MEMORANDUM: PLANNING CONSULTATION
--

**Land at Broad Street
Leek**

**Erection of 'Drive Thru' Coffee Shop (Use Class E)
with a loading area, car parking, 'drive thru' lane,
hard and soft landscaping; and other associated
works**

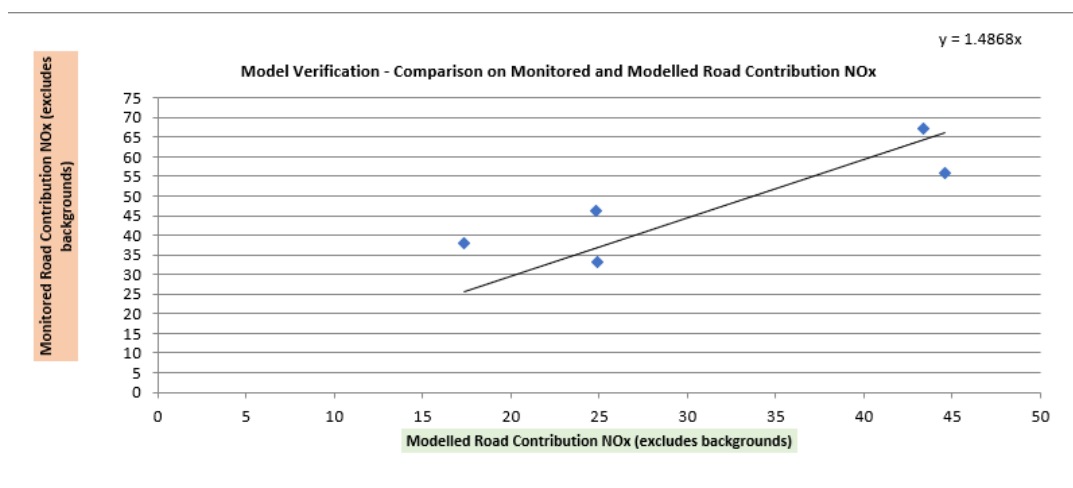
- The model set up appears generally** acceptable but does not present or discuss the initial Root Mean Square Error, this is desirable because if the initial RMSE was $> \pm 25\%$ then one would anticipate the model inputs (e.g. adopted speed @ 42) are reviewed prior to applying a correction factor. It would also be desirable to view the correlation in graphical form. It is noted that the RMSE improved to around 10% with the application of a correction factor, which is acceptable (though the error is not consistent both underpredict (42) /overpredict).

- When comparing the unadjusted total NO₂ derived from the model to the monitored concentrations, an RMSE of 21.2% was derived. I have provided below the graph of the model verification plotting each of the monitoring locations utilised in the assessment. The unadjusted model output RMSE falls within the acceptable 25% range, and further improves with adjustment and therefore it is considered that the model is performing statistically well and that the use of the adjustment factor provides robust results in the impact assessment.
